# ACCELERATED DISTRIBUTION DEMONSTRATION SYSTEM

SUBJECT: Responds to 920513 telephone request concerning containment failure probabilities.Enclosed find pie-chart of Containment Failure Fractions.

Re: Turkey Point Units 3 and 4  
Docket Nos. 50-250 and 50-251  
TAC Nos. M74482 and M74483  
Individual Plant Examinations (IPE) for Severe  
Accident Vulnerabilities (Generic Letter 88-20)  
Response to Request for Additional Information

# CONTAINMENT FAILURE FRACTIONS

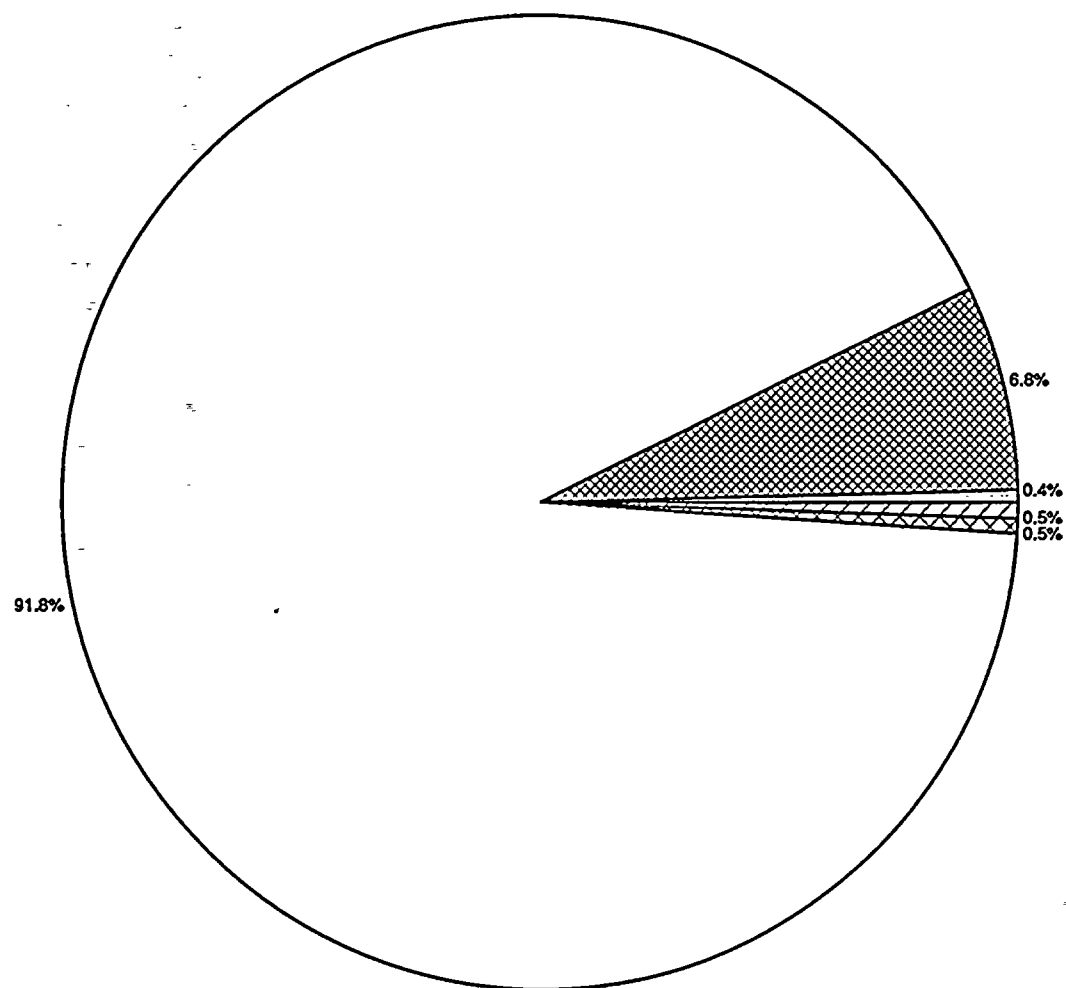
In response to the May 13, 1992 telephone request, please find attached a pie-chart of Containment Failure Fractions. The containment bypass sequence frequencies are  $6.24E-8$ /yr for Interfacing Systems Loss Of Coolant Accidents (ISL) and  $6.60E-8$ /yr for Steam Generator Tube Ruptures (SGTR). These reductions (from the June 25, 1991 submittal) result from more realistic estimates of operations non-recovery probabilities. For an ISL, the revised estimates are based on taking credit for time to Refueling Water Storage Tank (RWST) depletion, considering the capability of the non-accident unit's high head safety injection system to provide injection flow from the non-accident unit's RWST. Analyses show that this time is 6 hours, from start of an ISL, for Turkey Point. For an SGTR, the revised estimates are based on taking credit for nitrogen backup capability to the Atmospheric Dump Valves.
